IE Bulletin No. 78-05

MALFUNCTIONING OF CIRCUIT BREAKER AUXILIARY CONTACT MECHANISM -
GENERAL ELECTRIC MODEL CR105X

105X AUXILIARY CONTACT (CHANGEOUT OF PLUNGER ARM AND INSULATION)

FIGURE 1
REMOVING OVERLOAD RELAY MOUNTING BRACKET

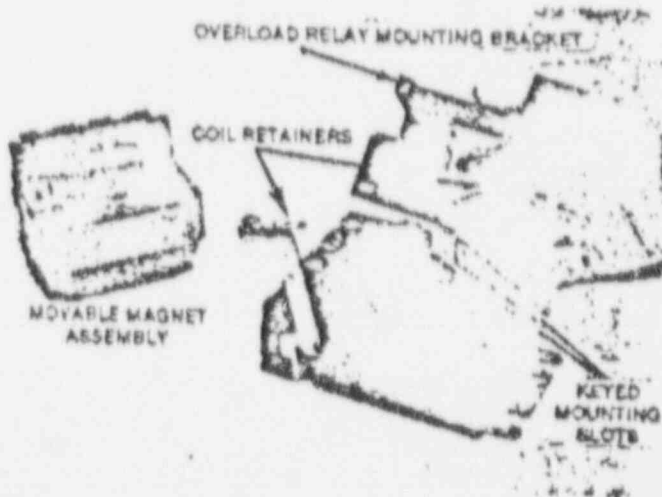
REMOVING OVERLOAD RELAY BRACKET (SEE FIG. 1)

1. Remove all electrical power from device.
2. Disassemble device by pressing on the coil while pulling out on the coil retainers. Move retainers back and away from coil.
3. Grasp movable portion of magnet and pull out, removing magnet assembly, coil, molded cover and movable arm in one motion. (NOTE: On reversers or multispeed starters, this magnet assembly is linked to the mechanical interlock arm between contactors and should be tipped toward interlock arm to facilitate easy removal.)
4. Remove overload relay bracket by sliding it out of the keyed slots in the molded base. (NOTE: If any wires are too short to allow easy removal, temporarily disconnect these.)
5. Remove overload relay from bracket by loosening screw on bottom of overload bracket.

FIGURE 2

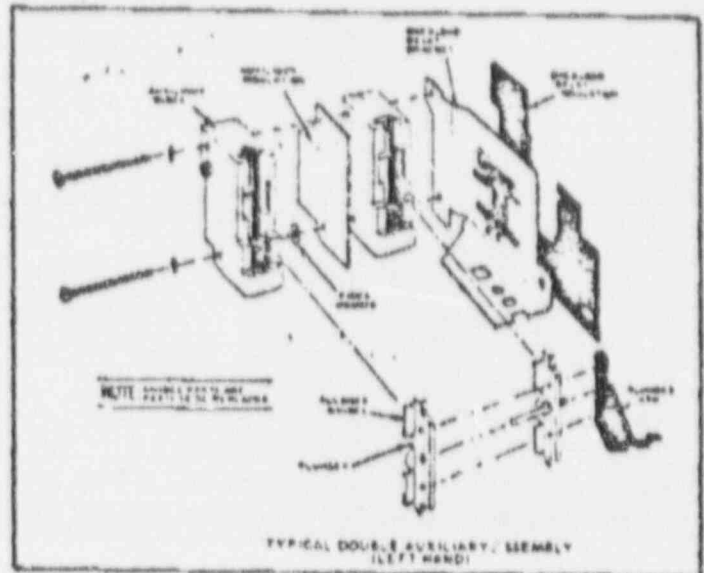
CHANGING PLUNGER ARM & INSULATION (SEE FIG. 2)

1. Slide plunger assembly out of auxiliary contact block, by lifting up and out.
2. Select the new plunger arm that is bent the same way as the one installed.

3. Loosen screw on plunger to release metal arm but (DO NOT REMOVE SCREW FROM PHENOLIC PLUNGER (OR PLUNGERS)).
4. Mount new plunger arm on plunger. Fasten arm to plunger with screw (or plunger post if installing double aux. blocks).

5. Apply thin coat of aeroshell grease along plunger guides.
6. Reinstall plunger assembly in contact block.
7. Reassemble overload to mounting bracket. Remove overload insulation and install new. (NOTE: Overload insulation must be removed and replaced with new insulation supplied with kit.)

8. Remount complete assembly on contactor base.
9. Reconnect any wires previously removed.
10. Reassemble magnet assembly to contact base (on reversers or multispeeds be sure to interlock this assembly with mechanical interlock arm. Check for free movement of armature assemblies and mechanical interlocks).

11. Observe that auxiliary contact plunger assemblies are operating properly.
